Access Compliance Report Public Rights-of-Way (Curb Ramps)

Intersection ID: N/A Main Street: E_4TH_ST **Cross Street: N/A** Location: N ADA ID: 5E2CAFF4F58E Ramp Type: PerpDiag Initial Pass/Fail: Fail **Overall Compliance: No Severity Score:** 27.5

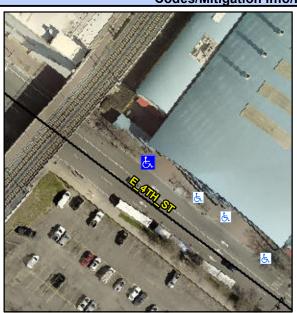
Possible Solutions: Remove & Replace Curb Ramp With **Two New Directional Ramps or** Equivalent. Surveyor Notes: N/A PROW/ADA: Not Found, R304.5.3, R302.7

Field Measurements/Component Compliance							
	Compliance Description		Data	Compliance Description		Data	
	N/A	Ramp Length (in)	53.0	Yes	Ramp	Slope (%)	6.0
	Yes	Ramp Width (in)	48.0	No	Ramp	XSlope (%)	5.4
	N/A	Flare Type LT	N/A	N/A	Flare	Type RT	N/A
	N/A	Flare Slope LT (%)	N/A	N/A	Flare	Slope RT (%)	N/A
	N/A	Flare Traversable LT?	N/A	N/A	Flare	Traversable RT?	N/A
	N/A	Landing Length (in)	N/A	N/A	DWS	Provided?	N/A
	N/A	Landing Width (in)	N/A	N/A	DWS	Contrast?	N/A
	N/A	Landing Slope (%)	N/A	N/A	DWS	Length (in)	N/A
	N/A	Landing X Slope (%)	N/A	N/A	DWS	Full Width?	N/A
	N/A	Landing Curb? (Y/N)	N/A	N/A	DWS	Offset (in)	N/A
	N/A	Shared Landing?	N/A				
	N/A	Gutter Ponding?	N/A	N/A	Gutte	r Slope (%)	N/A
	N/A	Gutter Lip Ht (in)	N/A	N/A	Gutte	r X Slope (%)	N/A
	N/A	Painted X Walk1?	No	N/A	Painte	ed X Walk2?	No
		X Walk 1 Direction	To SW		X Wal	k 2 Direction	To SE
	N/A	X Walk 1 Width (in)	N/A	N/A	X Wal	k 2 Width (in)	N/A
